Petition No. 297

**REQUEST BERM USE
 (For Parking Only)
 INTO OAKMAN BLVD.
 AT 12080 CLOVERDALE**

CITY OF DETROIT CITY ENGINEERING DIVISION	
SURVEY BUREAU	
JOB NO.	01-01
DRWG. NO.	X 297

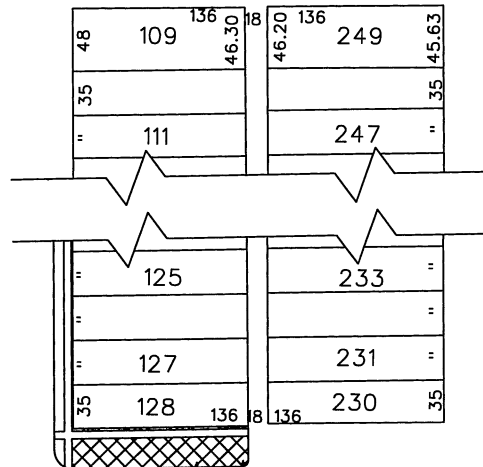
- () Not Involved.
- () Involved; but asking you to hold action on this petition until further notice.
- () Involved; the nature of our services, and the estimated costs of removing and/or rerouting such services are:
- (X) Involved; **have objection** to the request for berm use (for parking only) into Oakman Blvd. at 12080 Cloverdale as shown on drawing no. x297 dated 11/16/2018 since the requested area is less than minimum width (27 feet) required for 30 degree angle parking as contained in the Traffic Engineering Division Guidelines for Berm Parking. Traffic Engineering Division may reconsider the petition if a request is made for 1 lane parallel parking on the concrete berm.
